Contract #: 04-0120F4Cty: SF/ALA Rte: 80 PM: 13.2/13.9File #: 69.25B**QUALITY ASSURANCE -- NON-CONFORMANCE REPORT****Location:** Changxing Island, Shanghai, P.R. China**Report No:** NCR-000314**Prime Contractor:** American Bridge/Fluor Enterprises, a JV**Date:** 06-Jun-2009**Submitting Contractor:** Zhenhua Port Machinery Company, Ltd (ZPMC), Changxing Island**NCR #:** ZPMC-0288**Type of problem:****Welding****Concrete****Other****Welding****Curing****Procedural****Bridge No:** 34-0006**Joint fit-up****Coating****Other****Component:** OBG Suspender Brackets**Procedural****Procedural****Description:**

NON-CONFORMANCE REPORT TRANSMITTAL

Job Name: SAS Superstructure

Subject: NCR No. ZPMC-0288

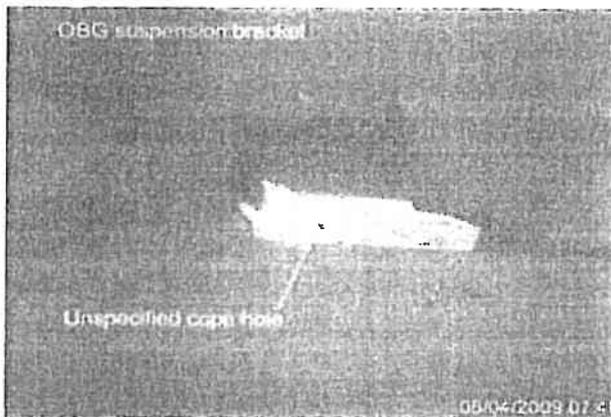
Caltrans Quality Assurance (QA) Inspector observed that the Contractor appears to either have a complete joint penetration (CJP) weld that has not been completed, or has an unspecified cope hole that is not identified on the approved contract drawings. The weld in question is located on the suspender brackets where the deck panel mounting flange (X53B) intersects and welds to the web plate. This condition was observed on Suspender Brackets SB20E, SB20W, SB22E, SB22W, SB24E, SB24W, SB26E, SB26W, SB28E and SB28W.

Contractor has acknowledged that this item must be addressed, and the item was added to the Master Punchlist.

Work was completed and last item was cleared on Master Punchlist by Caltrans on 6-5-2009. Submittal of documentation by Contractor being tracked on Documentation Punchlist.
